Suitability
Issued for Stage Approval

Project
6BKD1
Willmott Dixon

Drawing
Planting Plans

Project ID	Originator	Zone	Level	Type	Role	Number
6BKD1	- RYD	- ZZ	- XX	- DR	- L	- 70000

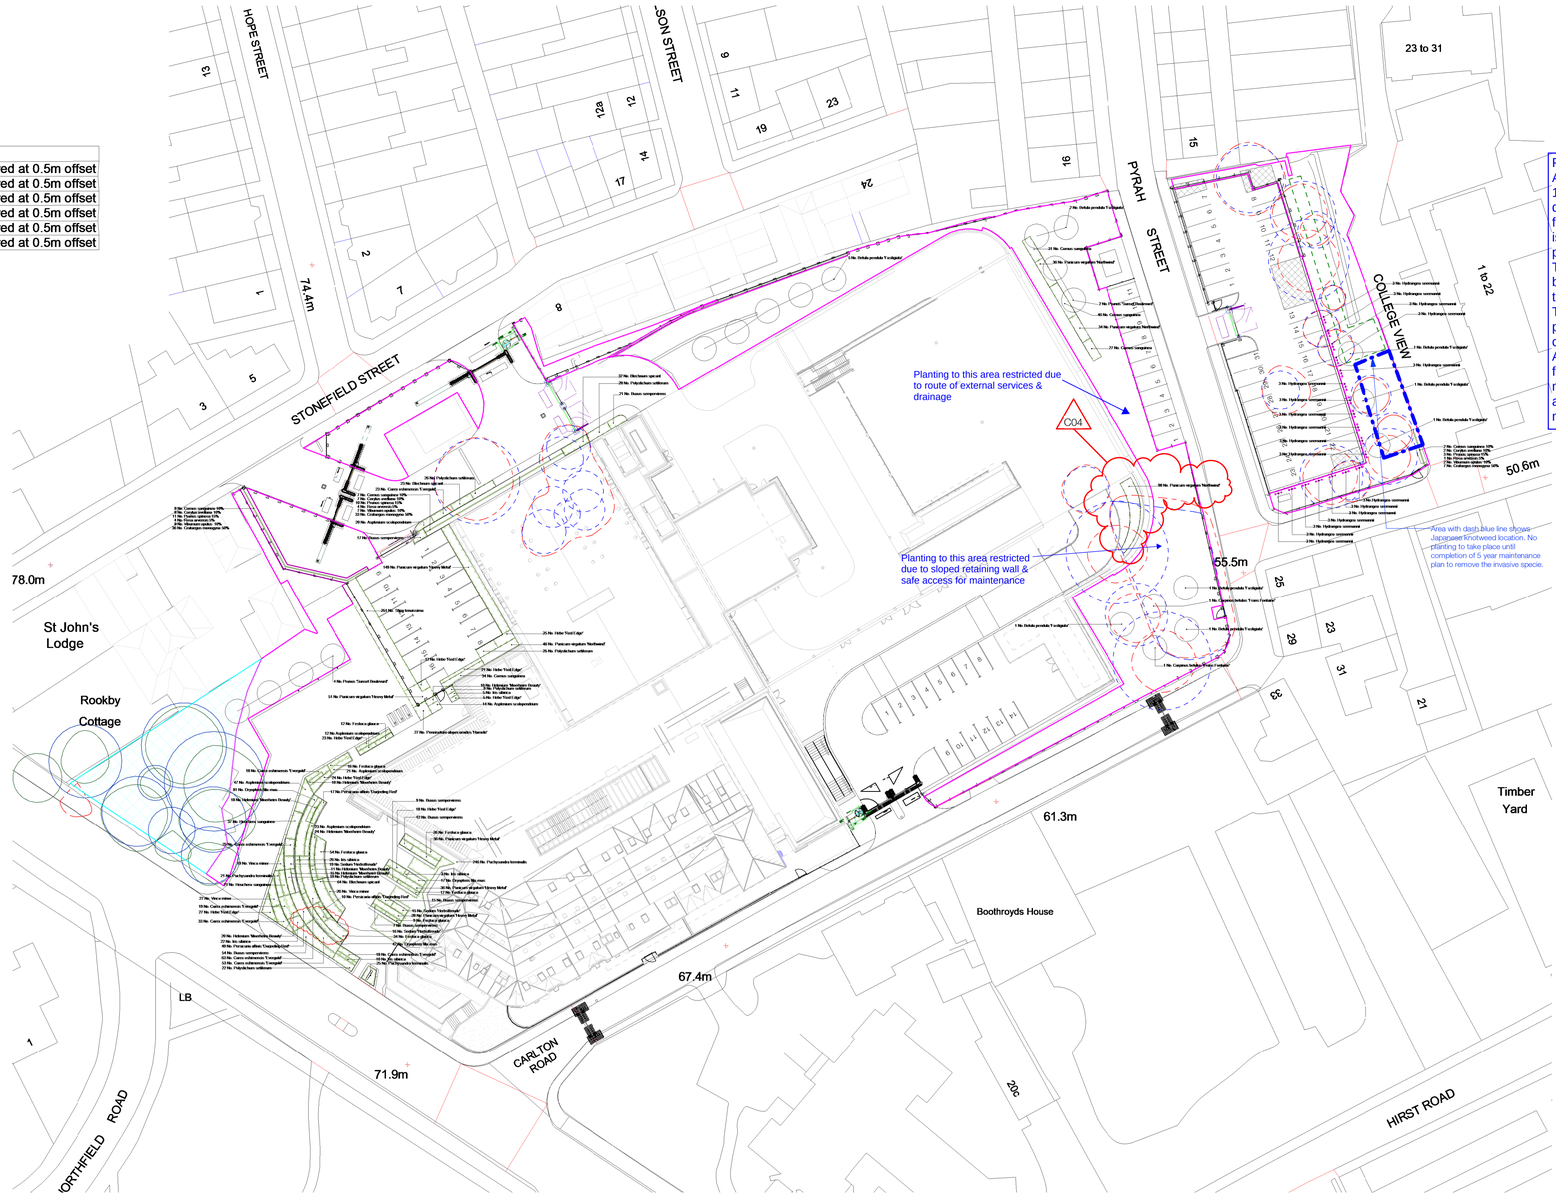
Principal Designer MSCP Planter comments:
After reviewing the initial design which positioned the 1100mm planter tight to the balustrade, there was a distinct concern with how this could aid potential falls from height, as well as create further maintenance issues due to the inaccessible gap between the planter and balustrade.
The solution for this, is to sit the planter circa. 500mm behind the balustrade, tapering it at the south end so that it does not act as a step up over the balustrade. This would still maintain the intention of providing planting to the top of the retaining wall and deflecting car lights from neighbouring premises.
Access for non-roadside maintenance is to be gained from the MSCP. All activities completed by the maintenance contractor are subject to a risk assessment and method statement. Warning signage may be required.
